re: **Geotechnical Design Summary Details**
Proposed Residential Development
5331 Fernbank Road – Ottawa, Ontario

file: PG5683-MEMO.02 Revision 5

Further to your request, Paterson Group (Paterson) prepared the current memorandum to provide a grading, servicing and landscape review for the proposed residential development. The following memorandum should be read in conjunction with the Geotechnical Investigation Report (Paterson Report PG5683-1 Revision 1, dated November 13, 2025).

DRAWING No.
121011-GP2

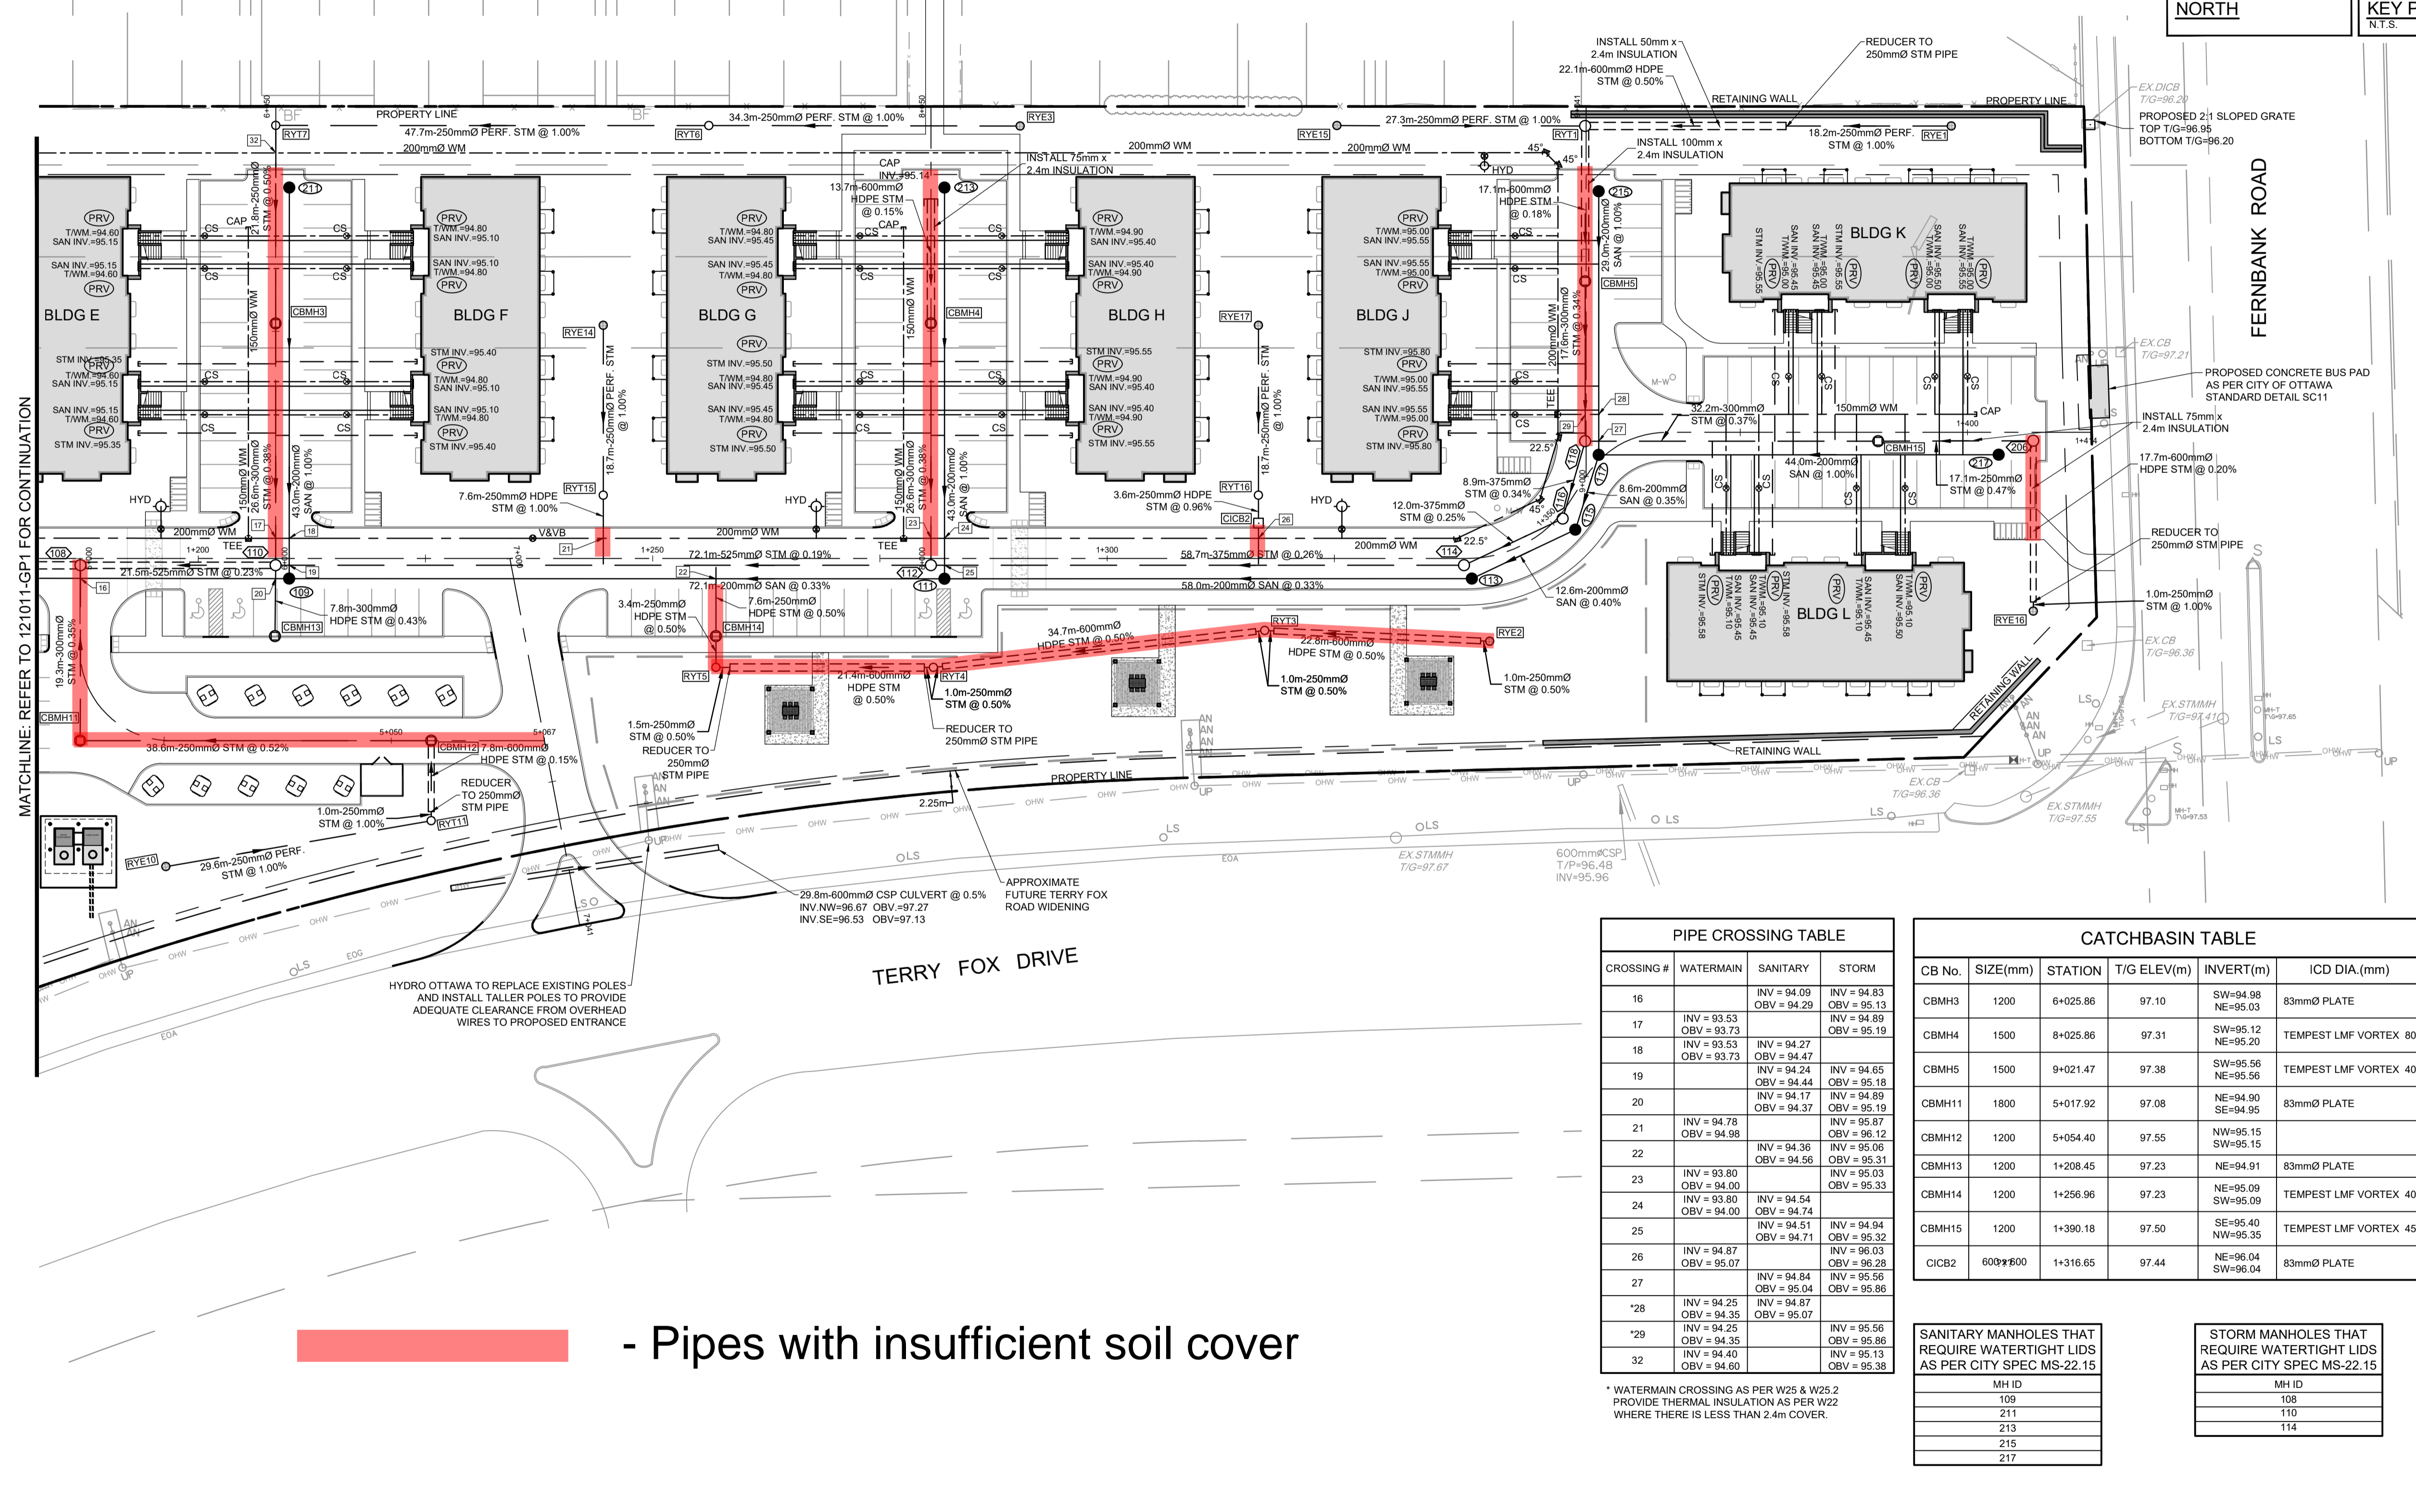
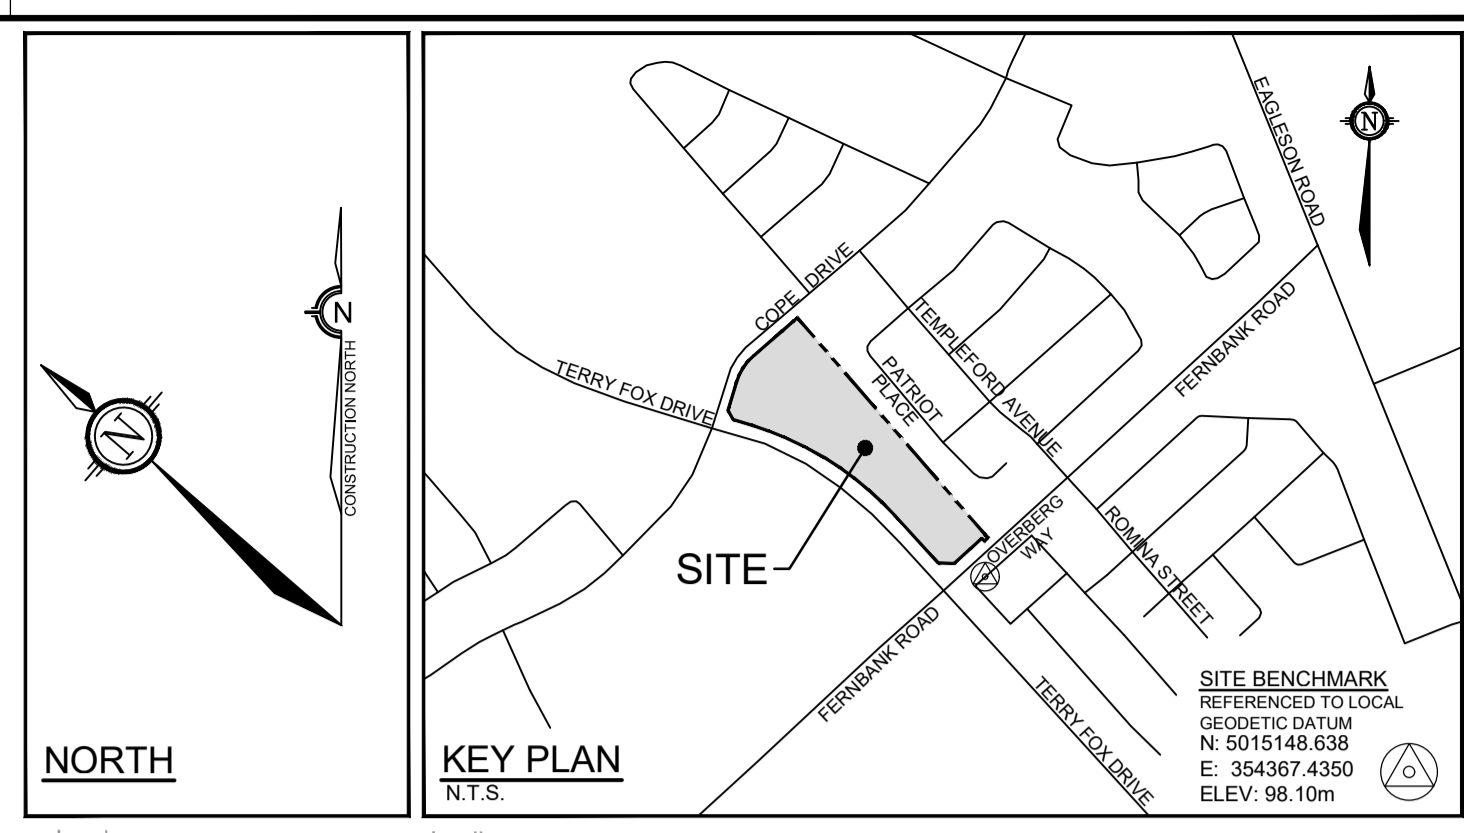
From our review of the above-noted site servicing plan, a number of servicing pipe sections are not provided with sufficient soil cover of 2.1 m for adequate frost protection (measured from the proposed ground surface to the pipe obvert). Reference should be made to the marked-up servicing plans which show the areas with insufficient soil cover, attached to the current report.

- Pipes with insufficient soil cover

For services with less than 2.1 m soil cover, a combination of soil cover and rigid insulation should be used, as detailed in Table 2 on the following page.

Thermal Condition	Soil Cover Provided (mm)	Insulation Dimensions	
		Thickness (mm)	Extension (mm)
Unheated	1800-2000	25	Extend 600 mm horizontally beyond edge of the pipe
	1500-1800	50	Extend 900 mm horizontally beyond edge of the pipe
	1200-1500	75	Extend 1200 mm horizontally beyond edge of the pipe

Alternatively, instead of extending the rigid insulation 600 to 1200 mm beyond the edge of the pipe, the rigid insulation can be “boxed” around the pipe by transitioning from horizontal to vertical placement of the rigid insulation and extending to the invert pipe elevation, effectively forming a box of rigid insulation around the pipe. In this case, the rigid insulation should still be extended far enough to provide adequate spring-line and cover backfill material around the pipe.
